<input type="checkbox"/> Sidewalk Waiver (Form V2)		
<b>SITE PLANS</b>		<input type="checkbox"/> Waiver to IDO (Form V2)	<b>APPEAL</b>
<input checked="" type="checkbox"/> DRB Site Plan (Form P2)	<input type="checkbox"/> Waiver to DPM (Form V2)	<input type="checkbox"/> Decision of DRB (Form A)	
<b>BRIEF DESCRIPTION OF REQUEST</b>			
Apartment complex development

**RE: Sonata Unit 4 Trails Apartments  
Tracts 1, 2, and 3, The Trails Unit 4  
Second DRB Submittal**

PROJECT NAME: SONATA TRAILS UNIT 4 APARTMENTS

SHEET NUMBER: C-100

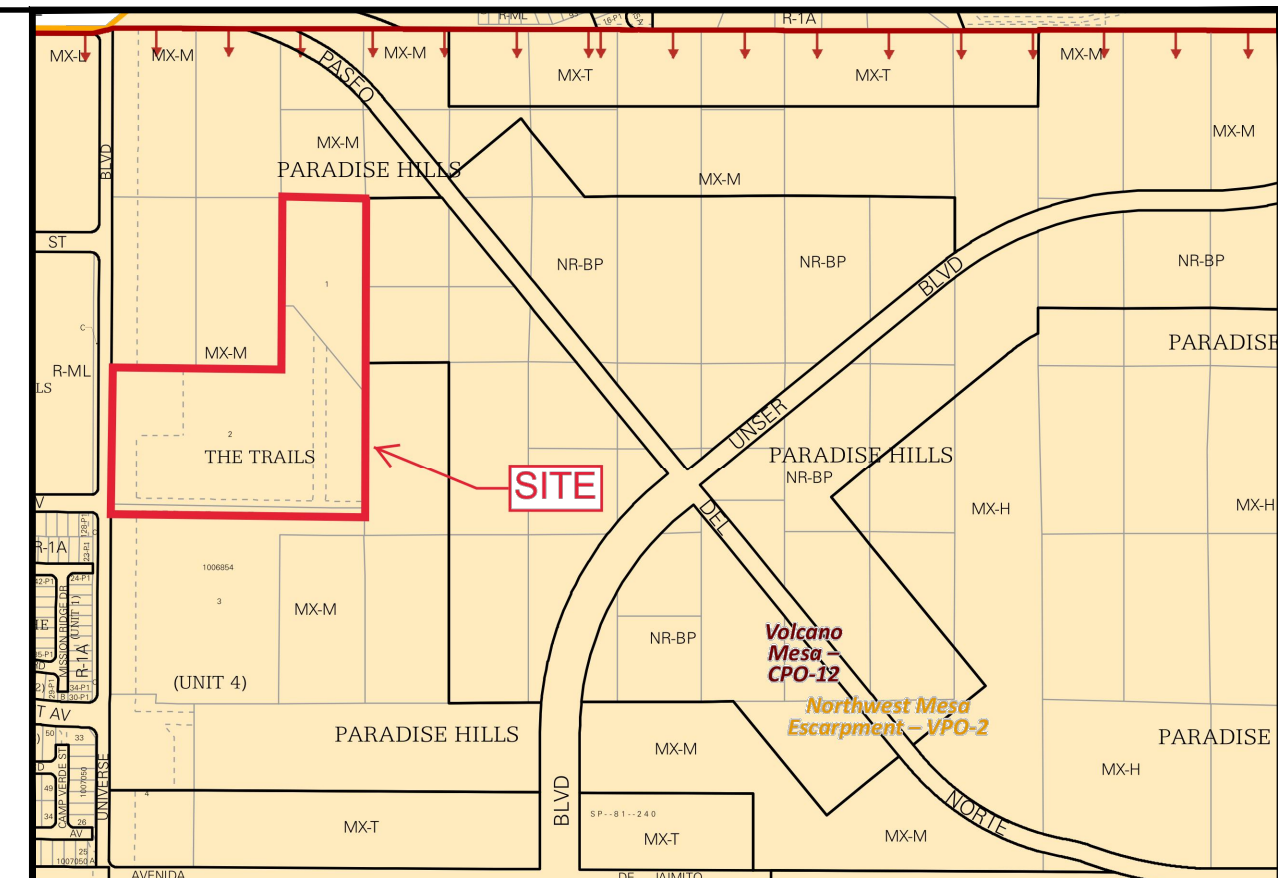
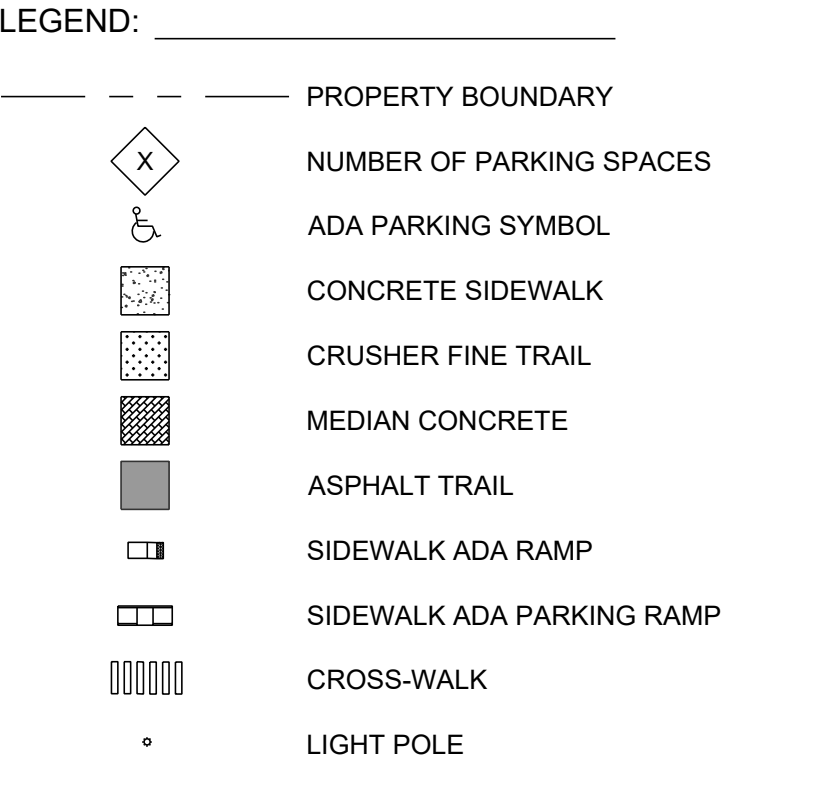
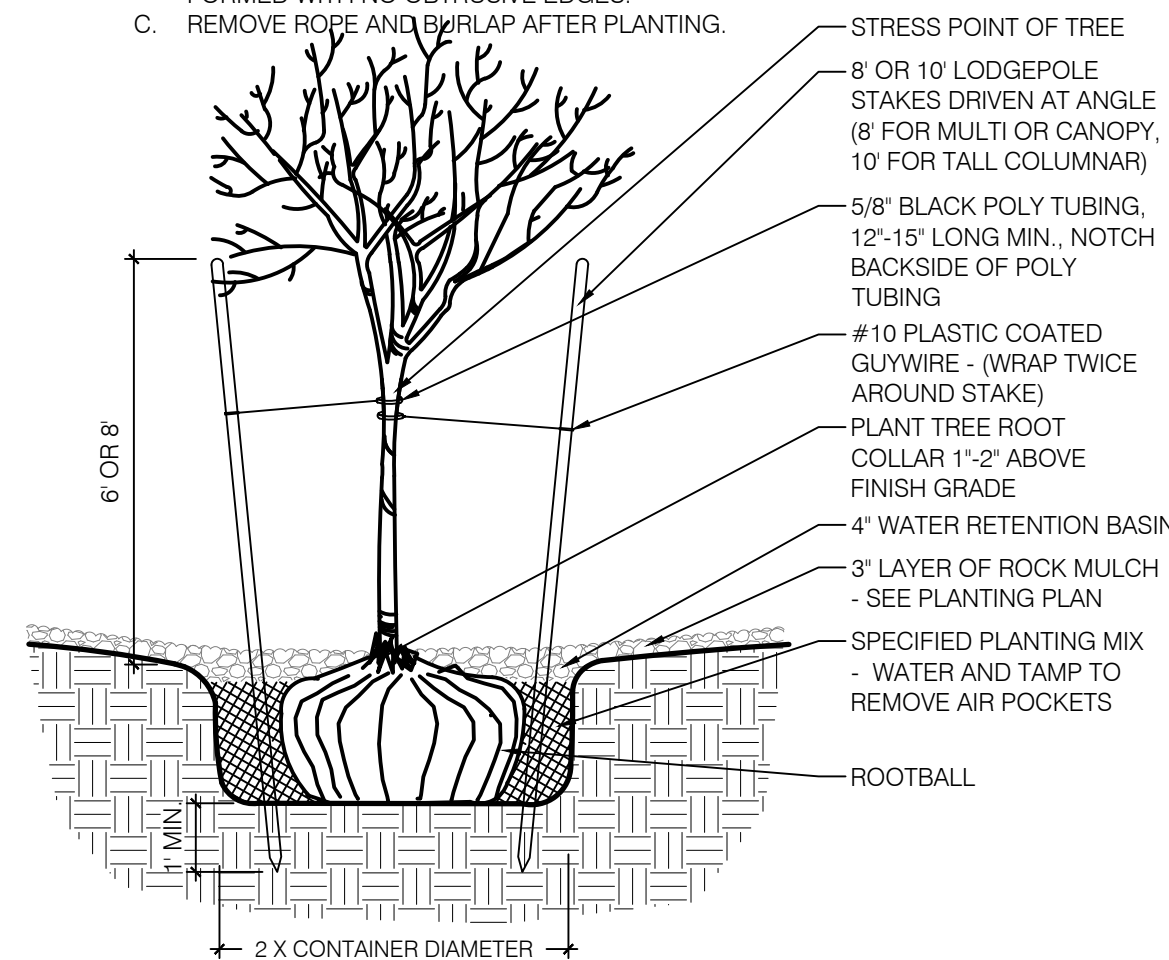
- The Code Enforcement signature line is missing from the Site Plan on Sheet C-100.  
/ Code Enforcement signature line has been added. See revised site plan.
- The Color, Reflectivity, and Roof-Mounted Equipment requirements for the Northwest Mesa Escarpment – VPO-2 must be met as listed below:

- The Site Plan mentions the proposed development as multi-family dwellings, but the design of the proposed dwellings seem to be townhomes. Please clarify this on the Site Plan.

- There appear to be pedestrian connections to sidewalks along the street frontages of Chatsworth Avenue and Treeline Avenue, but it's not clear on the Site Plan if there would be sidewalks along those frontages.

- Staff requests that benches be placed in the open space areas on the site outside of the central recreational area.
- / Benches were provided in the western open space area. Additional benches have been added throughout the site outside of the central recreational area. See revised site plan.

- / Four 1-bedroom units have been added to the second floor of the clubhouse building. We believe this meets the definition of a multi-family development rather than townhomes. See revised site plan.

- / Sidewalks and trails along property frontages will be built with this project. A hatch for off-site walkways has been added for clarity.
- Frontier Elm trees depicted on the Landscape Plan are not on the City of Albuquerque's Tree List.

- / The Frontier Elm has been removed. See revised landscape plan.
- Need lighting details.
- / Locations for site lighting have been added. See revised site plan. This is shown for informational purposes. A final lighting design will be provided at building permit.

## LANDSCAPE PLAN

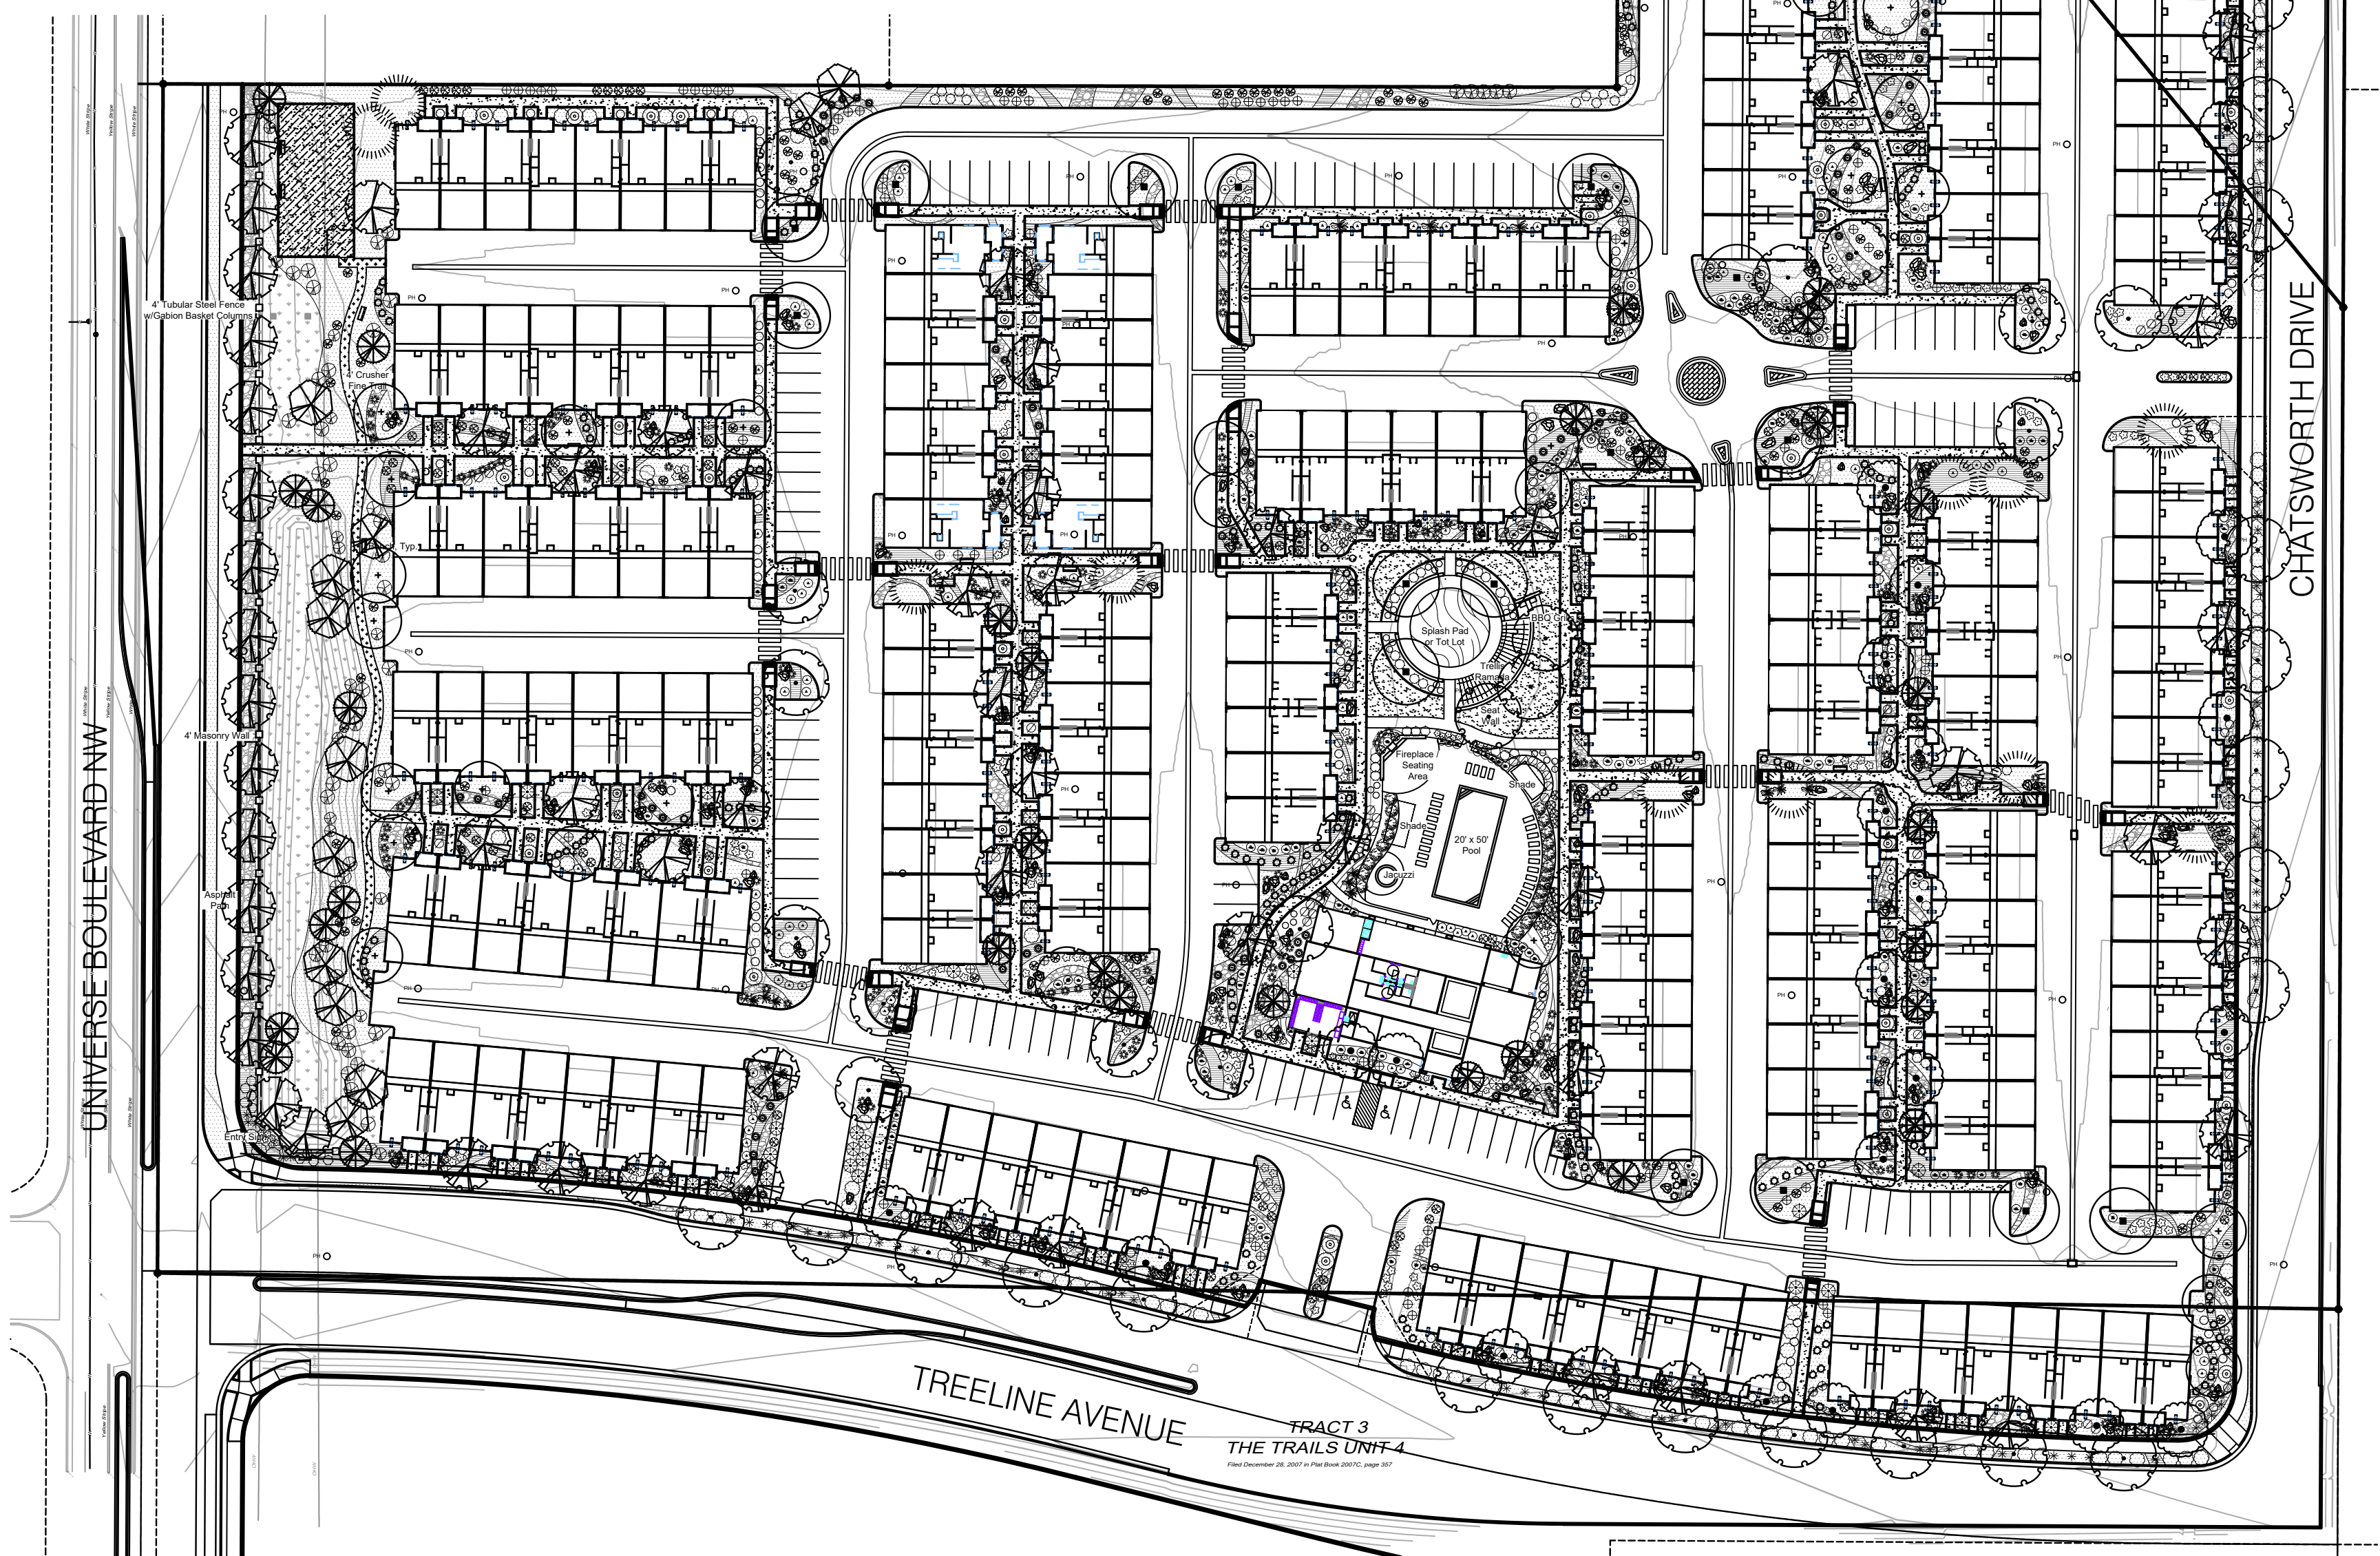
The Official Albuquerque Plant Palette and Sizing List was developed to encourage more drought tolerant species as the climate changes, and it is requested that the developer re-consider the large trees species. Frontier Elm is not on the list and may need extra irrigation. Lacebark Elm is still recommended. Raywood Ash should also be re-considered.

- / Street trees have been added along Universe spaced 25-ft on center. See revised landscape plan.

- / The Frontier Elm has been removed. See revised landscape plan.
